DSOS204A-02B

Modification Recommended Service Note

DSOS204A - DSO Infiniium S Series 2GHz 4 channel

The Problem - Under certain circumstances a PLL2 error may occur on the S-series products.

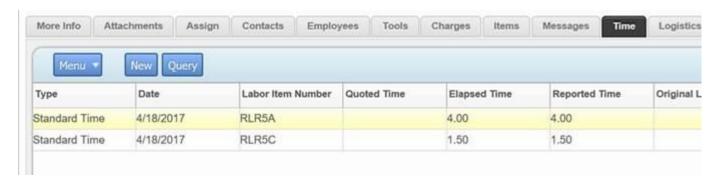
On older acquisition boards a PLL2 error message sometimes occurs. The error message appears on the screen as below:

There are new acquisition boards that fix this issue for the S-series scopes.

- 1. If the customer needs to have software revision < 6.10, then replace the acquisition board with the 54911-69532 board.
- 2. If the customer can have software revision > 6.10, then it can be replaced by any of these three boards: 54911-69521, 54911-69531, or 54911-69532.
- 3. Save the Serial Numbers of the replaced and the new Acquisition Boards in Siebel. Please, follow this procedure:
 - a. For each Service Order in Siebel, there is a tab labeled Activities:
